Case Number __<u>ZC-20-125</u>

ZONING MAP CHANGE STAFF REPORT

Owner / Applicant: Justin's Place

Site Location: 500 - 800 blocks Sycamore School Road Acreage: 4.59

JUSTIN'S PLACE: THE NEST **PLANNED DEVELOPMENT** SITE PLAN (PD

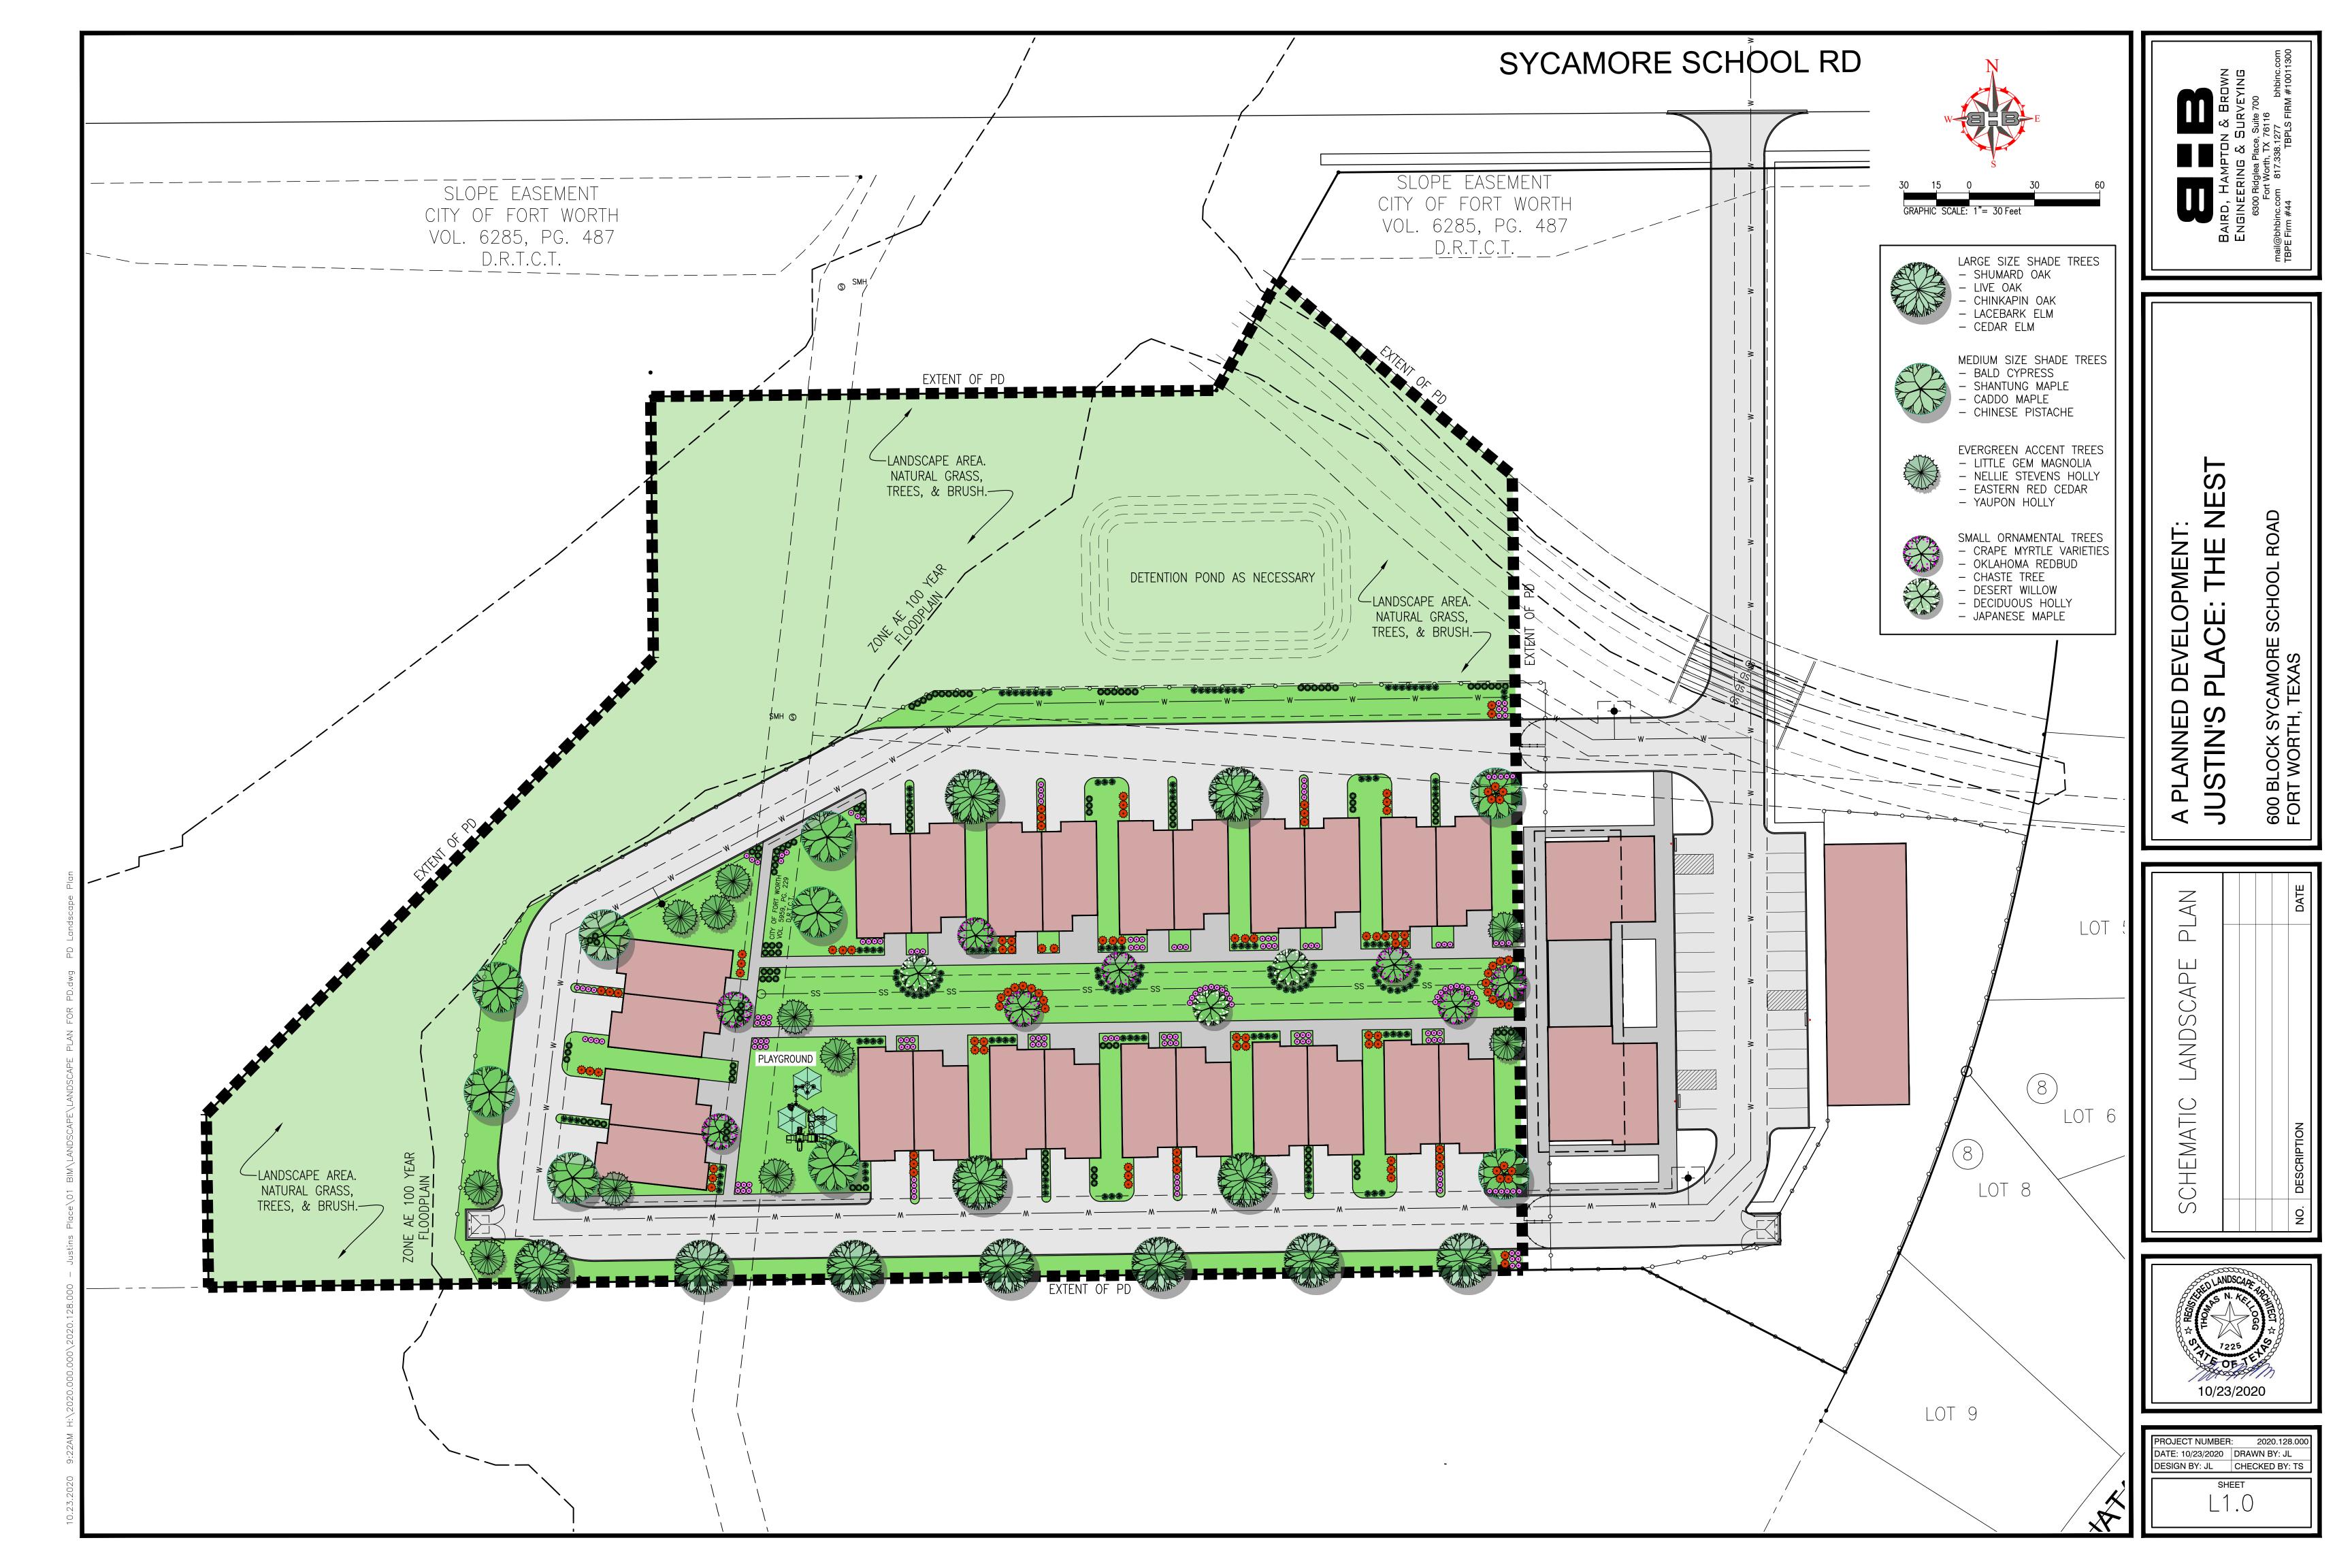
The site plan as submitted is not in general compliance with the Zoning Ordinance regulations.

- 1. The building orientation requires all building to have their longest side facing the adjacent street. (*Development Regulation Standard*)
 - Analysis: Based on the proposed cottage community not being the typical multifamily layout, staff supports the building orientation layout.

- 2. Parking requirement is 1 space per bedroom. Site plan shows two spaces per unit. (*Development Regulation Standard*)
 - Analysis: The site plan is meeting the parking standard for A and B zoned districts.
 Detached multifamily developments function as a hybrid between single family and multifamily, therefore staff supports the new parking requirement

- 3. Setbacks adjacent to A or B districts is 3:1 with a 30' minimum. Maximum building height is 20' which requires a 60' setback (*Development Regulation Standard*)

- Must meet 20 points of enhanced landscaping. Applicant has provided a landscape plan to add landscaping elements around the community greenspace area. (*Development Regulation* Standard)

- Analysis: Based on the configuration of the site and the development not being a typical multifamily design, staff supports the new setback regulations.

- Analysis: Based on the requirements of enhanced landscaping to be part of the public realm, staff feels that the new landscape plan addresses the interior community needs. Therefore, staff supports the new landscape plan
